DESIGN REVIEW: RECOMMENDATION

1422 SENECA STREET, SEATTLE, WA 98101

PROJECT #:3034493-EG

CORNER SITES
(CS2.C.1)

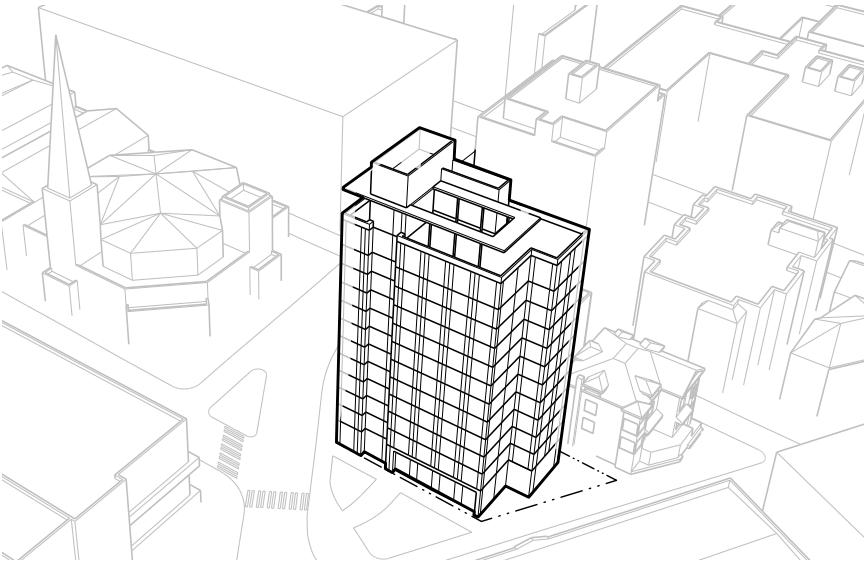
The Board supported the thinness of the massing for both it's expression of the innovative construction type and it's potential to lessen impacts on light and air on adjacent sites and streets.

The Board expressed concerns regarding the roof canopy expression in the preferred option, and requested further study of this element and it's role in the larger composition.

Building massing is consistent with the early design guidance preferred scheme. The triangular shaped lot allows the building to step back from adjacent streets, while the proposed courtyard minimizes light and air impacts on adjacent buildings.

The secondary roof canopy has been removed and the south massing has been extended to integrate a smaller canopy at the elevator penthouse.

FITTING OLD AND
NEW TOGETHER
(CS3.A.1)

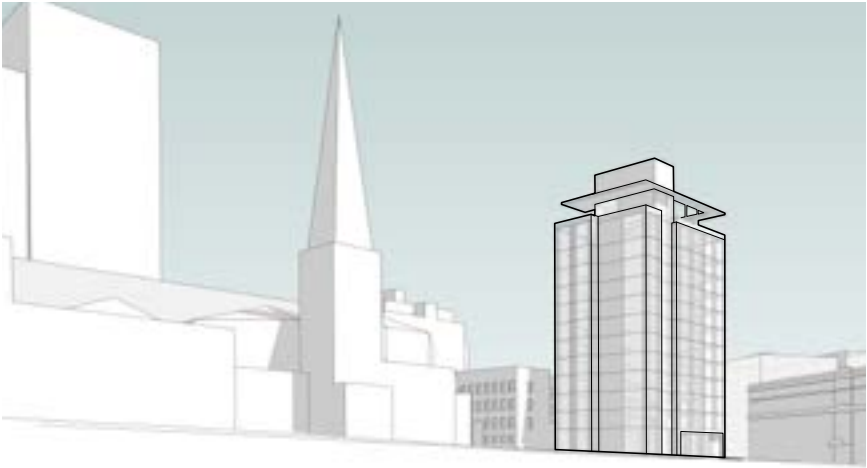
The Board questioned the connection between the height of this project and that of the spire at the landmarked Seattle First Baptist Church, and asked that a more rigorous conceptual analysis be developed of the forms in this neighborhood and this proposals response to that context.

The height of the building is not tied to the church spire, rather the height is an intermediate tower that is appropriate at the edge of the highrise zone. The building takes advantage of views to Seattle First Baptist Church.

1422 SENECA STREET

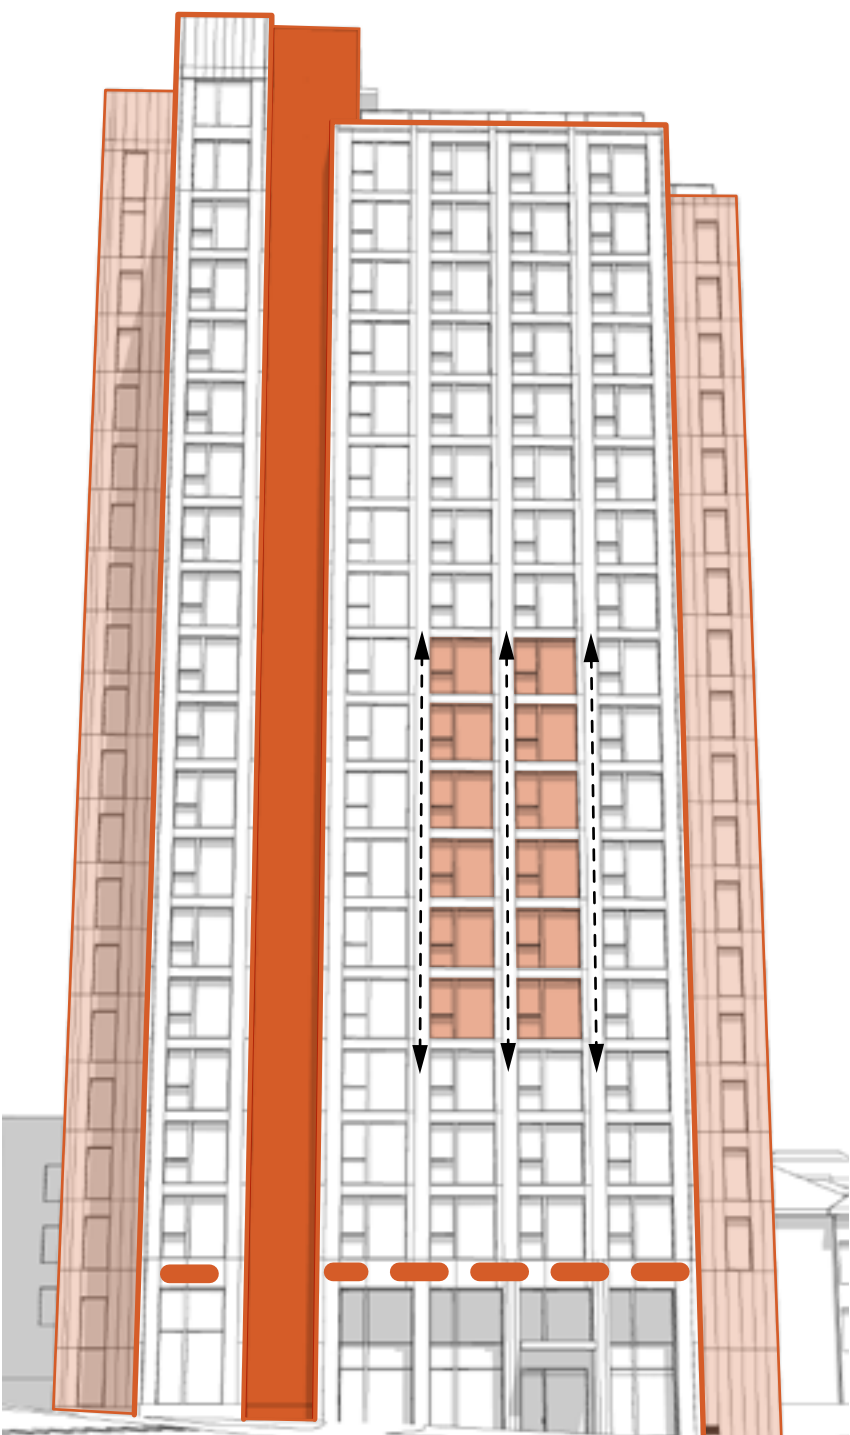
Given the applicant's intent to specify a high-quality, but very modern cladding system for this project, the board agreed that analysis of the rich surrounding historical context and demonstration of how this modern expression will connect with that context would be required for the next meeting.

The historical context and newer towers in first hill take advantage of simple massing articulation that emphasize a primary form.

The proposed exterior palette utilizes high quality cladding materials that emphasize the verticality and thinness of the design. Large expansive windows are used at the primary facades of each residential unit,, similar to the large window at Luma and Talisman.

EDG RESPONSE - GROUND FLOOR RESOLUTION [8.0]

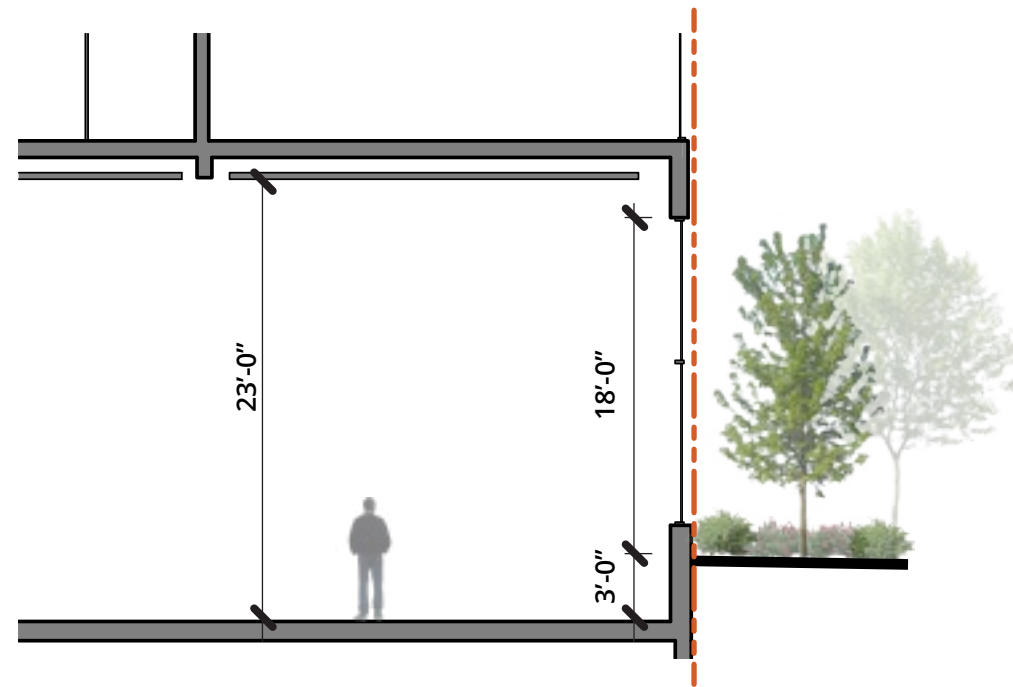
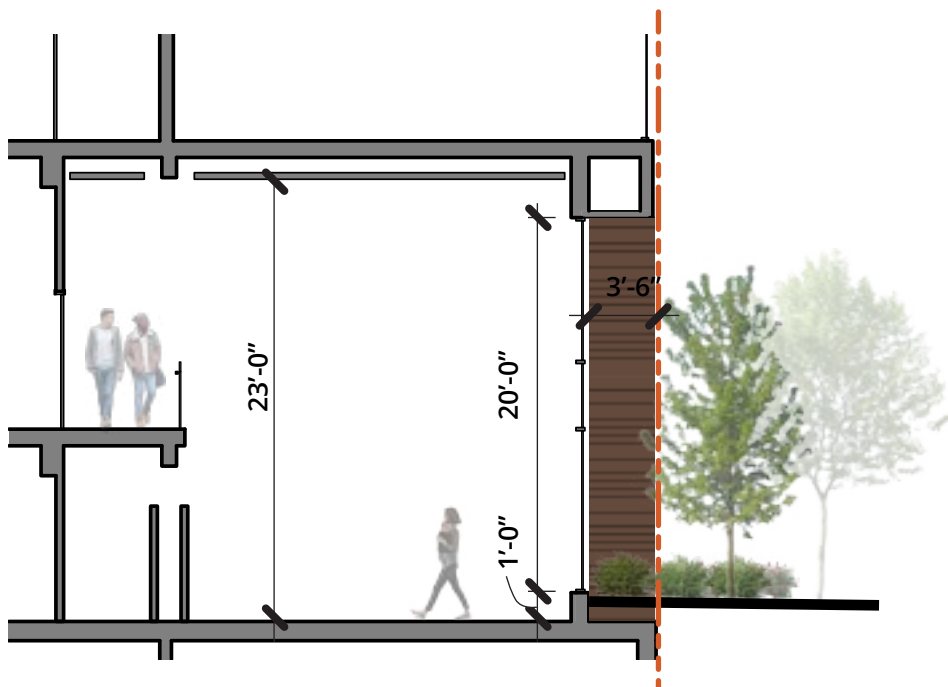
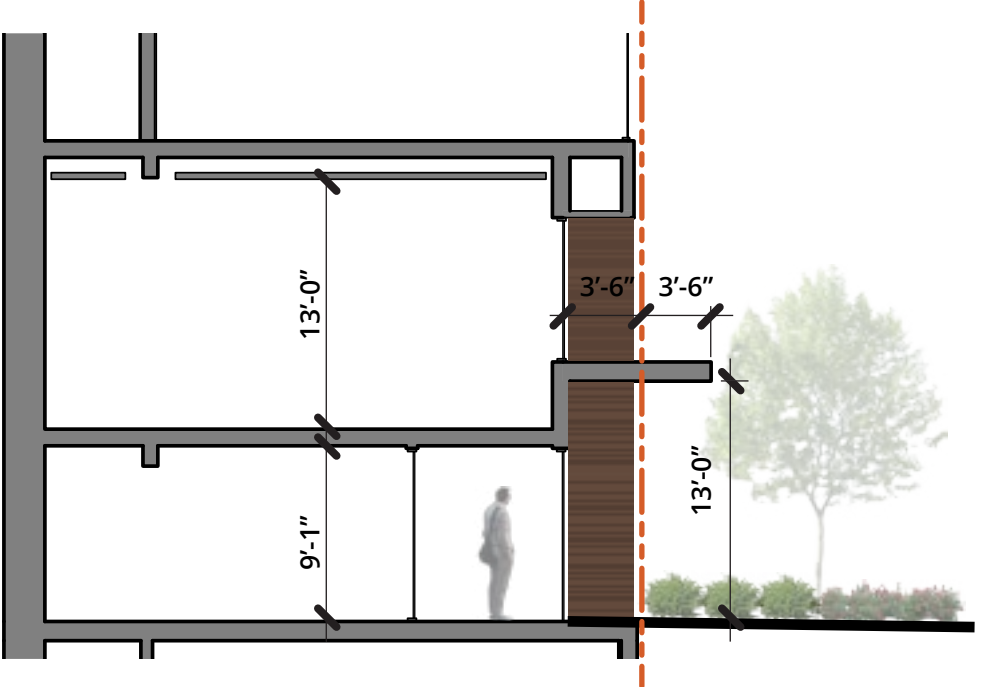
The Board was concerned to find few details regarding the design of the ground plane and pedestrian experience. The Board provided guidance with those edges should activate the sidewalk without appropriating the associated public spaces, and that complete details be provided for the next meeting, including entrance locations, inside/ outside relationships, resolution of grade issues, and the courtyard area fronting Maxmillian apartments.

The Board recognized that the park-like triangle of space directly north east of the site is part of the city right of way, but emphasized how important the development of this space would be to the pedestrian experience of this project.

The public right of way will be developed as part of this proposal to create a neighborhood amenity with public seating, lighting and gathering space. Sections provided at the ground floor transitions represent the resolution in grade through landscaped areas.

The public plaza will include public seating, lighting and gathering space. The primary residential entry is accessible from the new plaza. The public plaza will add to the evolving First Hill network of public spaces. See landscape for more details.

EYES ON THE
STREET
(PL2.B.1)

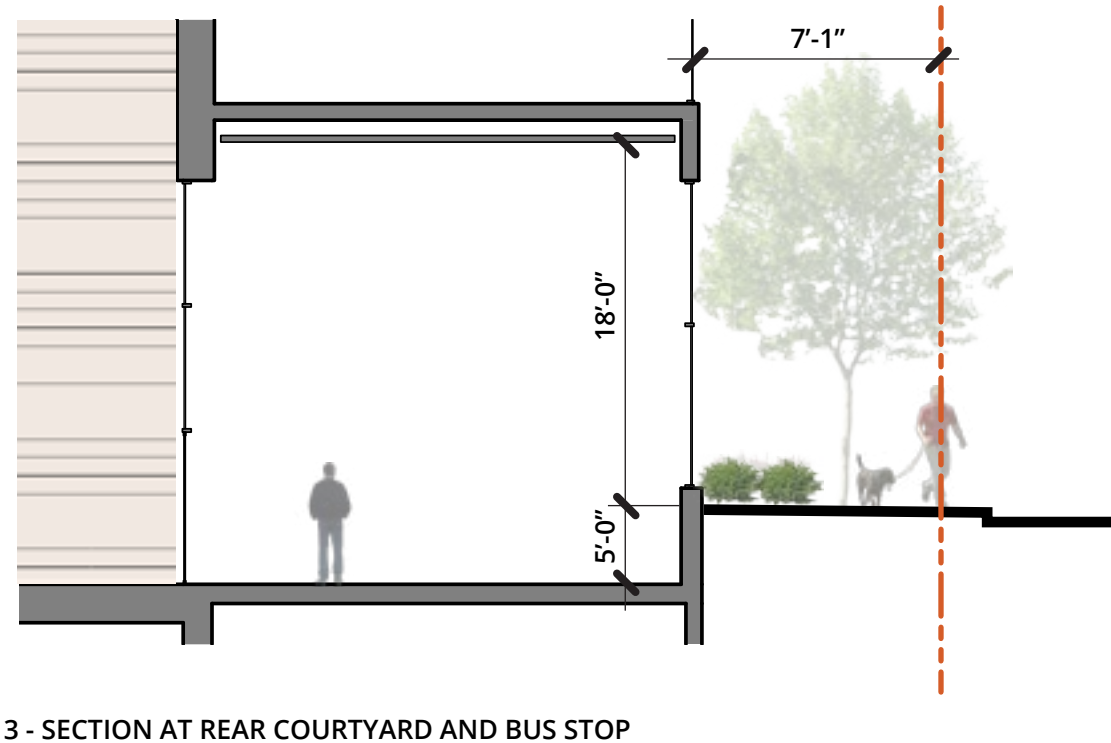
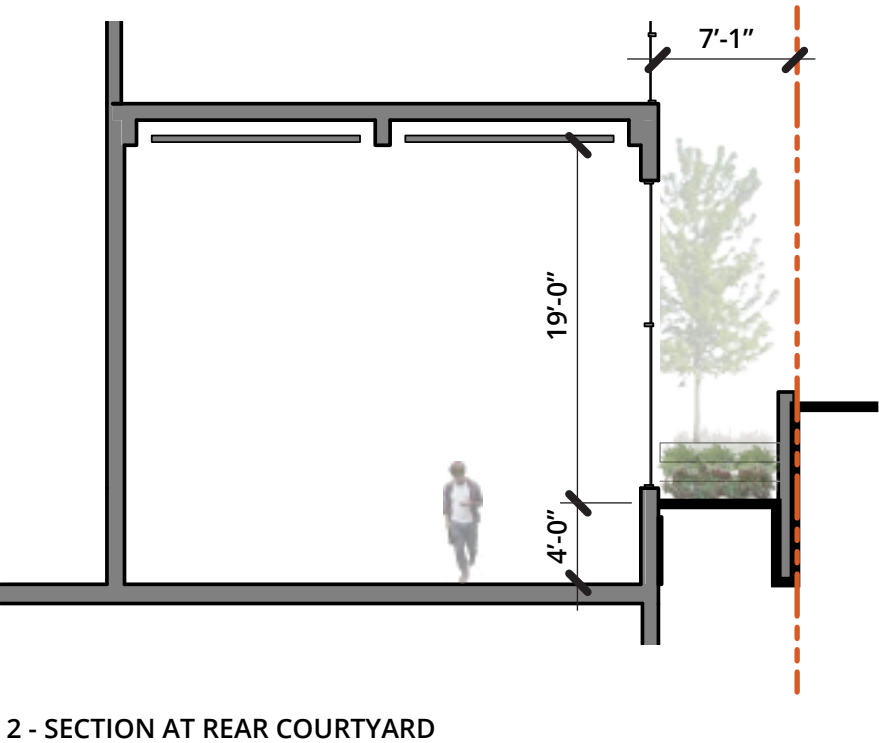
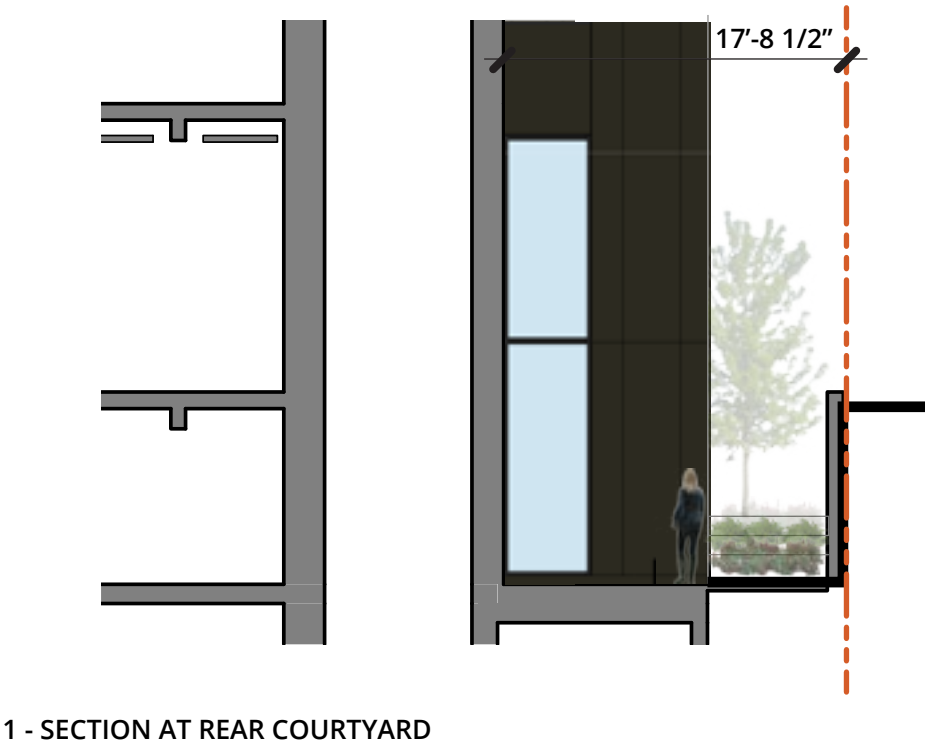
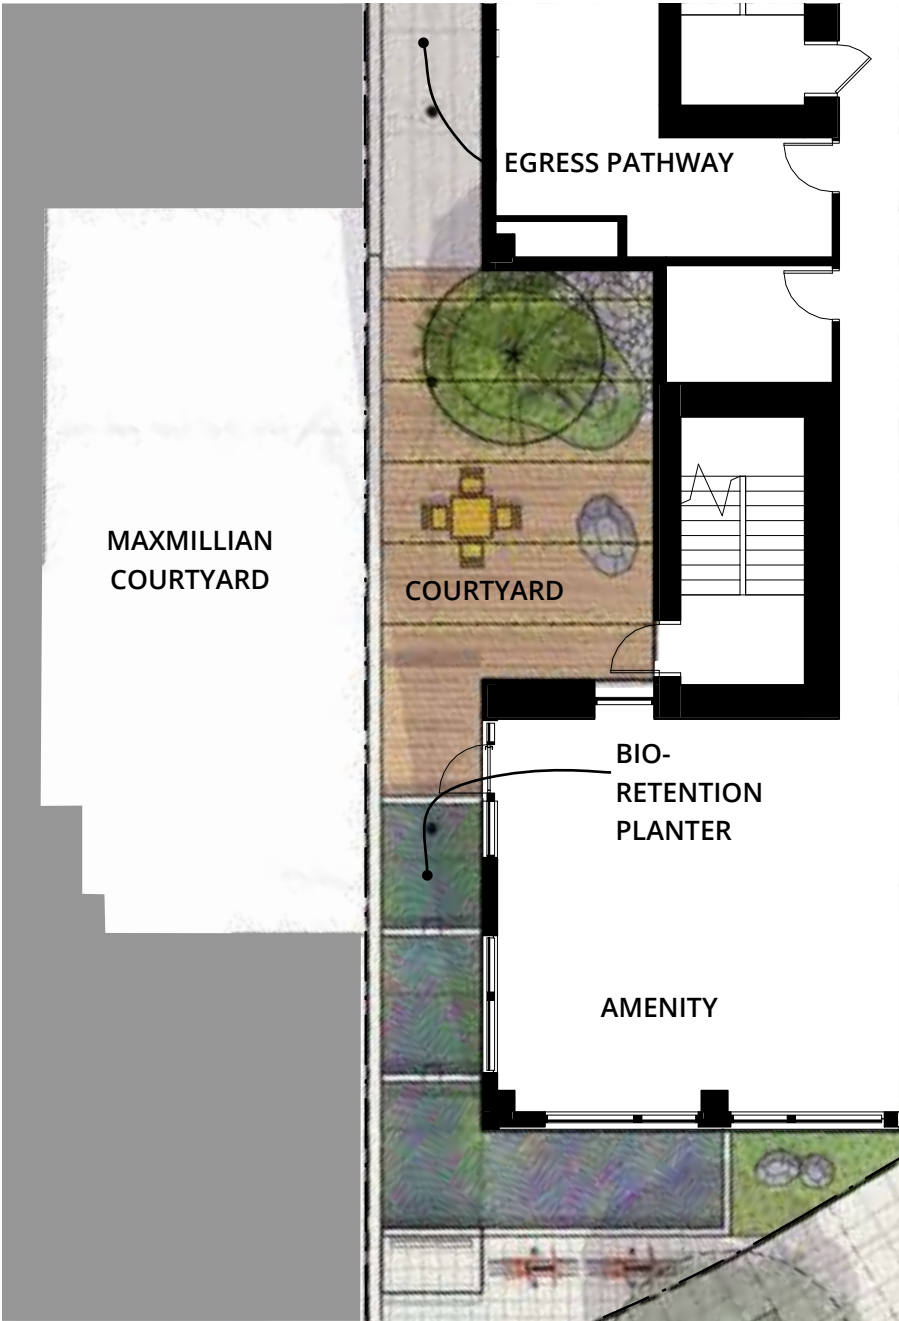
The Board recognized that the concrete base that typically creates a podium expression would not be required for this project, but agreed that a change in exterior expression recognizing connection to the ground would likely still be appropriate.

The 'base' is defined by a tall ground floor with large expanses of glazing that is recessed in the CLT structural grid. The horizontal datum is thickened at the transition between the ground floor uses and the upper floor residential language above.

ENLARGED SITE PLAN REAR COURTYARD

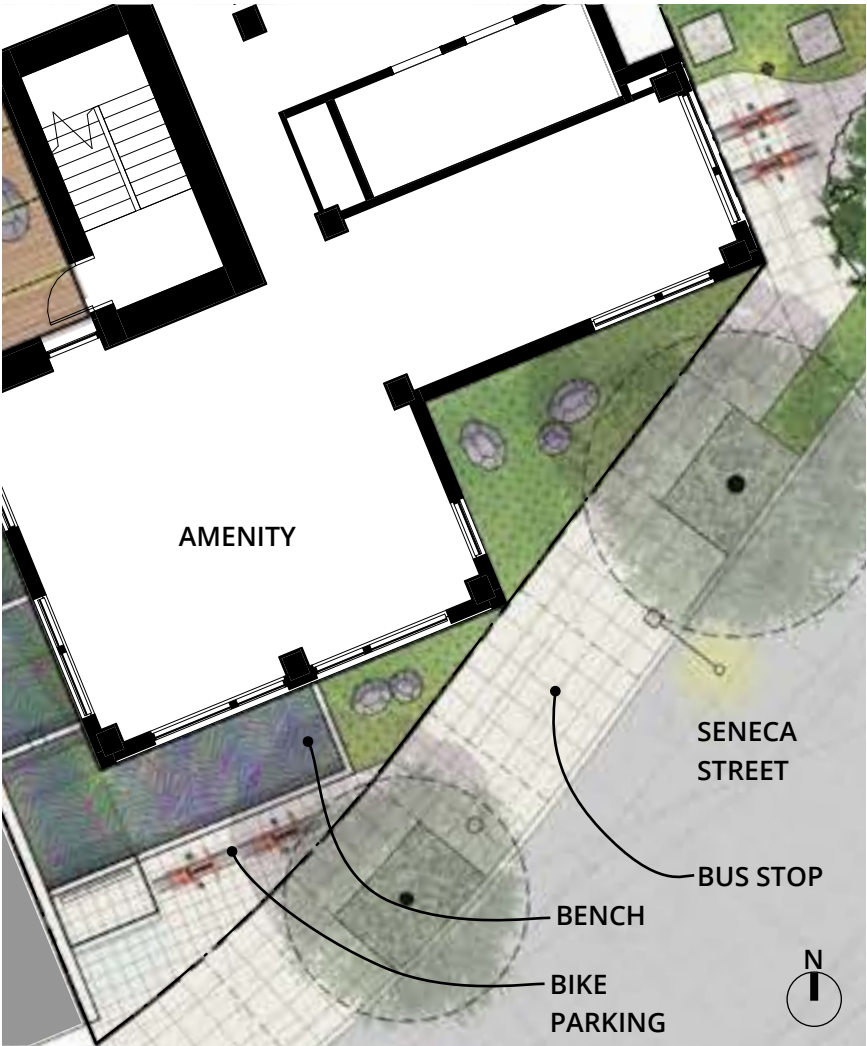
The Board discussed the lobby and amenity spaces at some length and concluded that regardless of their disposition, they would activate and engage the surrounding streets and open spaces.

The ground floor lobby and amenity spaces incorporate large areas of glazing at the public interface to the East and South to activate the surrounding streets and open spaces. The interior courtyard provides direct connection to the amenity space.
